Subject: McGuire Nuclear Station
Docket Numbers 50-369 and -370
Catawba Nuclear Station
Docket Numbers 50-413 and -414
Technical Specification Revision to Change Method of
Measuring Reactor Coolant System Flow Rate; Supplemental
Information

REQUEST FOR ADDITIONAL INFORMATION
REACTOR COOLANT SYSTEM (RCS) FLOW MEASUREMENT METHODOLOGY

Figure 25

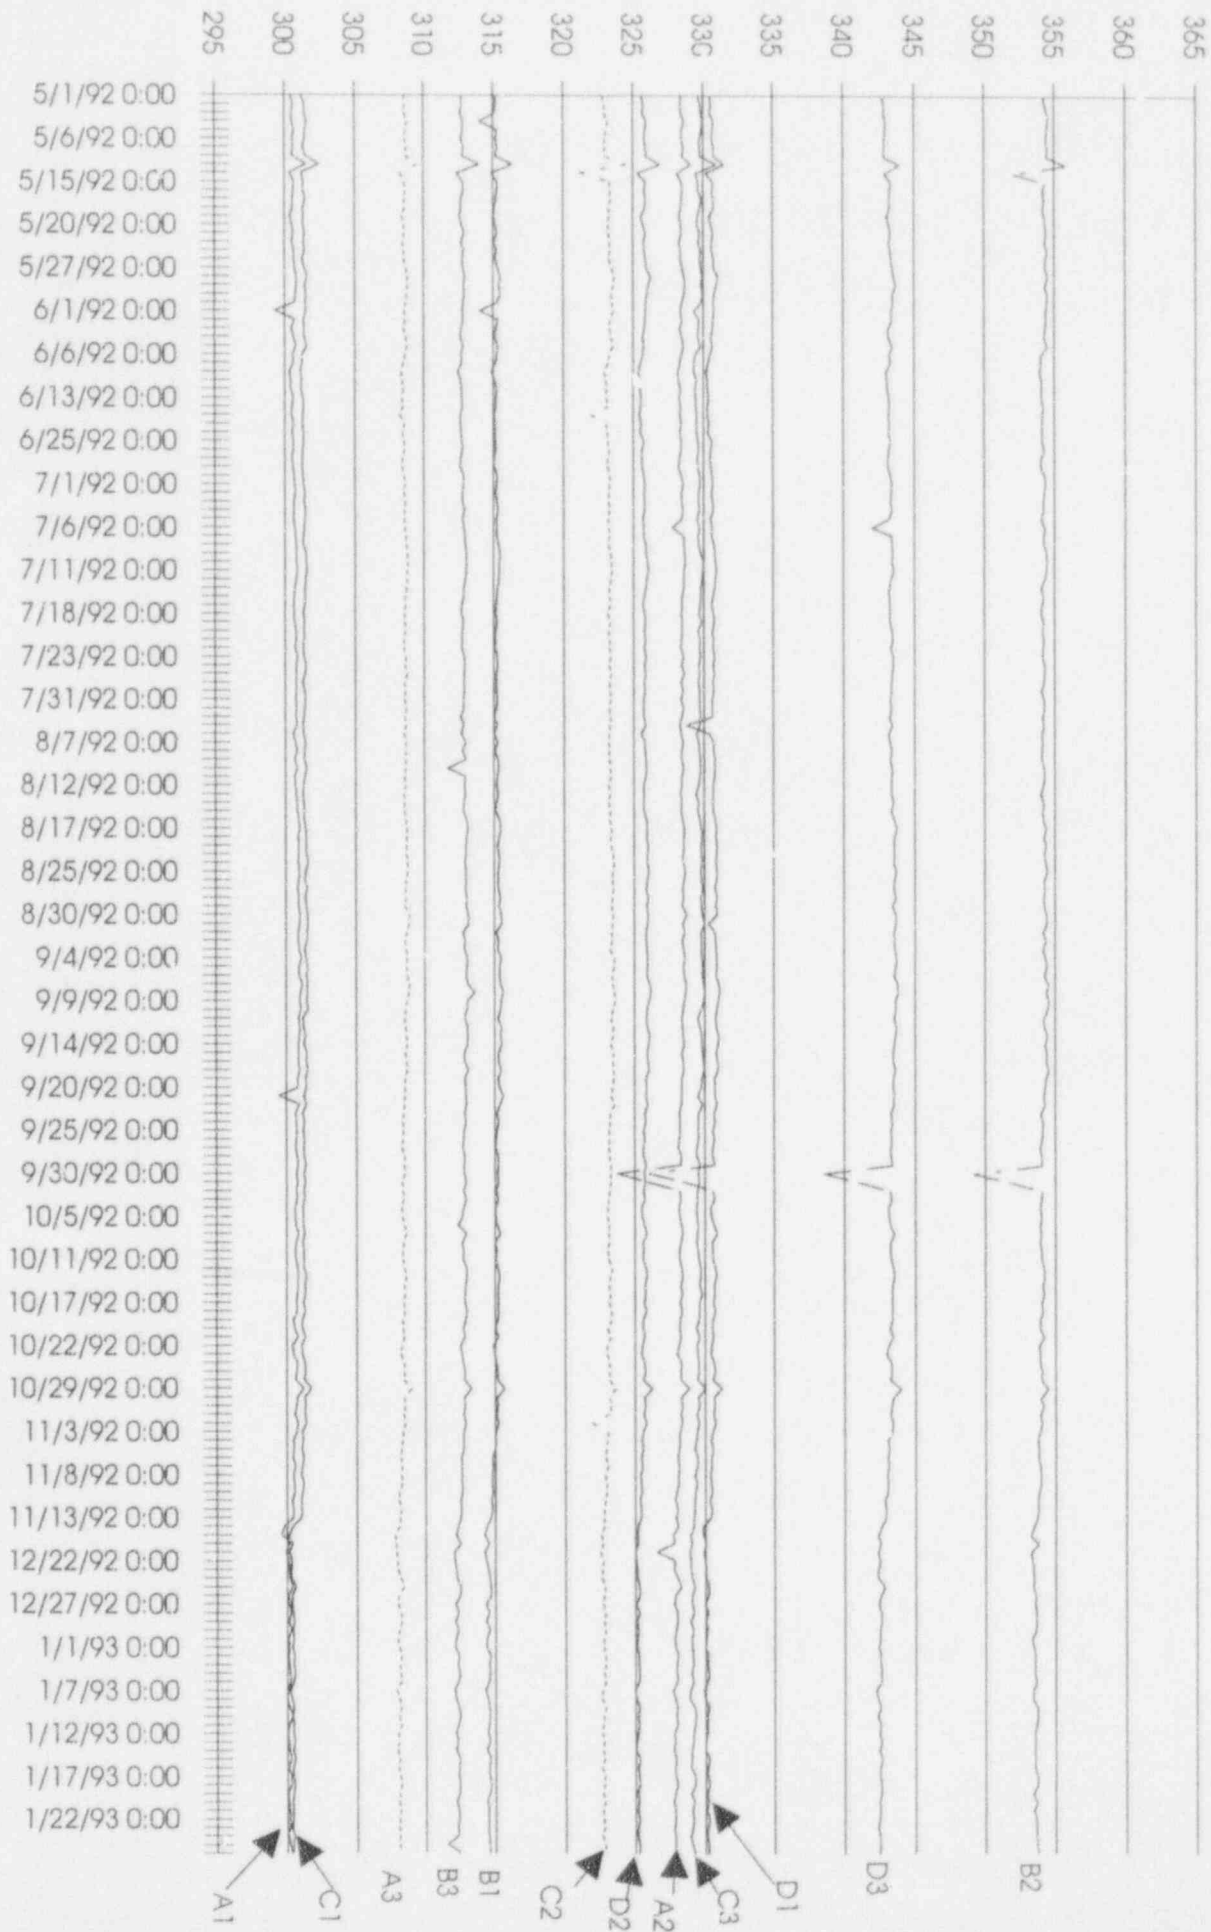
- (8) Please provide a comparison of analyses and observed RCS loop/total flow rate behavior as determined from elbow tap differential pressure indications and from calorimetric testing for both Catawba and both McGuire units. Sufficient data should be used to establish that:

Figures 25 and 26 show the daily average elbow tap ΔP data for Catawba Unit 2 back to May 1, 1992. This data covers cycles 5 & 6 and has been modified to eliminate bad data and data at off power days (<99% power). The data shows that the elbow tap ΔP s are very steady with no major drifting trends when the transmitters are operating properly. Channel B2 did have drift problems during cycle 6 and was replaced during the last outage. The numerous random small dips in the ΔP indications are the result of a bad data point in the daily average. Occasionally a point will read invalid by the computer and this will be recorded as a zero reading for the 5 minute period in question. This causes the daily average for that day to read slightly low resulting in the small dips in the elbow tap ΔP s.
